APPEAL # 7

APPEAL REQUEST

2021-2274-ZC

Petitioner: All State Financial Company

P.U.D. CONCEPTUAL PLAN AND TENTATIVE SUBDIVISION PLAN
VIEWX CARRE SECTION 46, T-7-S, R-11-E ST TAMMANY PARISH, LA.

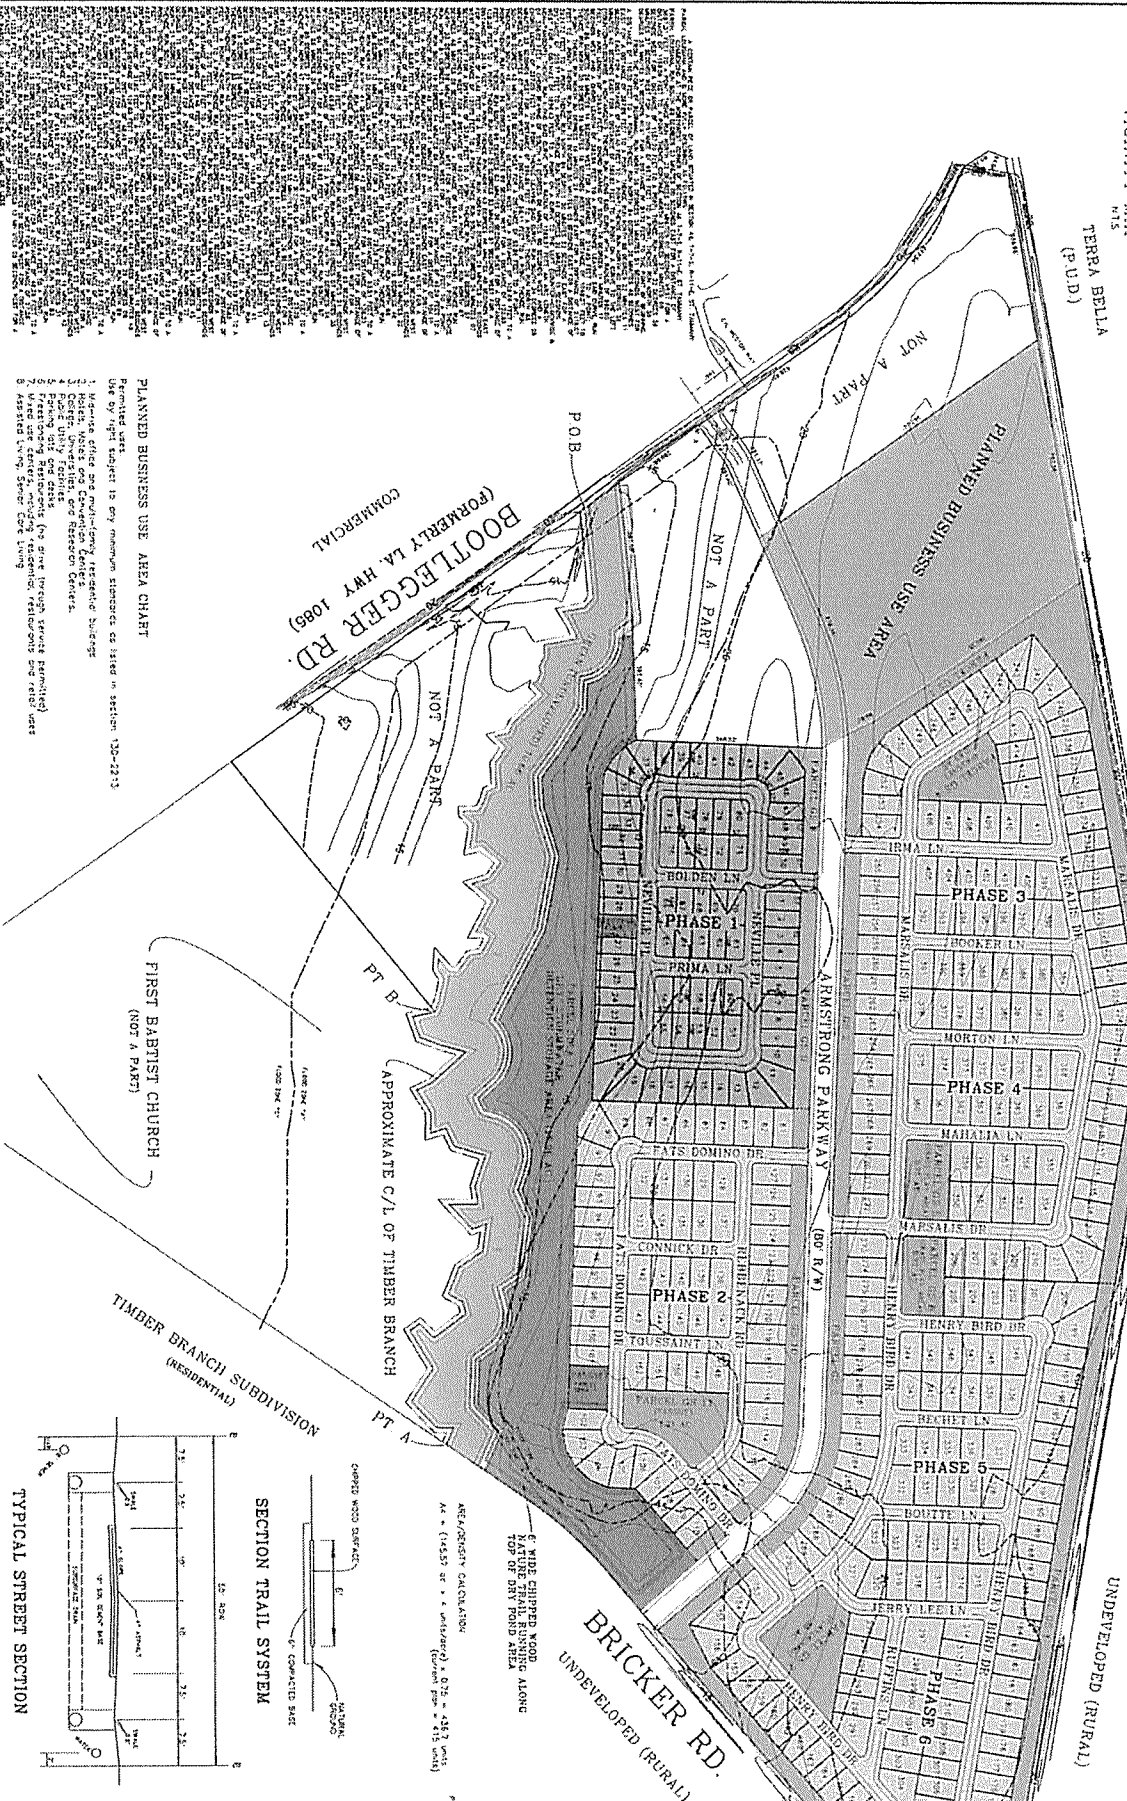
- a. A complete Recreational Development Plan shall be submitted depicting the proposed amenities, a time schedule for development, and the entity whom shall be responsible for the liability and maintenance of the recreational amenities and greenspace areas.

- The proposed PUD plan is providing 335 standard lots which are dimensioned at 60 ft. x 120 ft. and 80 garden home lots which are dimensioned at 50 ft. x 100 ft. – 120 ft. As submitted, there is no diversification of single-family housing types. The 14.87 acre “Planned Business Use Area” provides a mix of uses.

3. *Functional and beneficial uses of open space areas.*
 - The proposed PUD plan has allocated 10.66 acres of undeveloped greenspace to act as water access to Timber Branch. This access has no formal entry point and residents looking to use this recreational area will need to first traverse the 16.96-acre dry detention storage area. Staff recommends establishing a formal entry point for residents to actively use the space as well as the creation of a potential permeable parking area.

- The active recreational space that is proposed along the south side of the property includes nature trails. These trails appear to run in an east-west manner, in-between the dry stormwater area and the area dedicated to water access for the residents. These trails do not connect to the servitude which acts as the only formal access to these greenspaces and abruptly end at the edge of the site plan. The petitioners should reorient these walking paths to be inclusive of the entire useable portions of the greenspace as well as to provide access from the residential areas to Timber Branch.

- The natural greenspace areas located along the southern perimeter of the proposed PUD should be placed into a conservation easement. This easement would permanently limit the use of the land and ensure the public benefit of open space is maintained.

5. *Creation of a safe and desirable living environment for residential areas characterized by a unified building and site development program.*
 - The proposed PUD plan should provide a formal access and extend the walking trail from the residential area to the greenspace which is provided along the south side of the plan. This addition will help to create a unified building and site development program.

- The applicant must provide a complete Recreational Development Plan at the Tentative or Preliminary phase.

- The proposed traffic circulation consists of one collector type road known as Armstrong Parkway which will service 263 home sites along the north side of the development and 152 home sites along the south side of the development. The road is bordered on either side with a 50 ft. buffer which will help to alleviate noise and increase safety to the abutting homesites. Staff recommends the applicant mimic the boulevard type entryway which is shown at the intersection of Bootlegger Road and Armstrong Parkway along the intersection of Bricker Road and Armstrong Parkway.

- The current configuration shows the proposed commercial area having access along Armstrong Parkway, which is the main roadway which provides access for the 415 proposed residential dwellings. As the permitted uses for the commercial area appear to provide uses consistent with large-scale office development, the applicant should increase the buffer in-between the commercially zoned portion of the PUD and the residential uses. Staff recommends the applicant ensure additional stress on current traffic situations are mitigated.
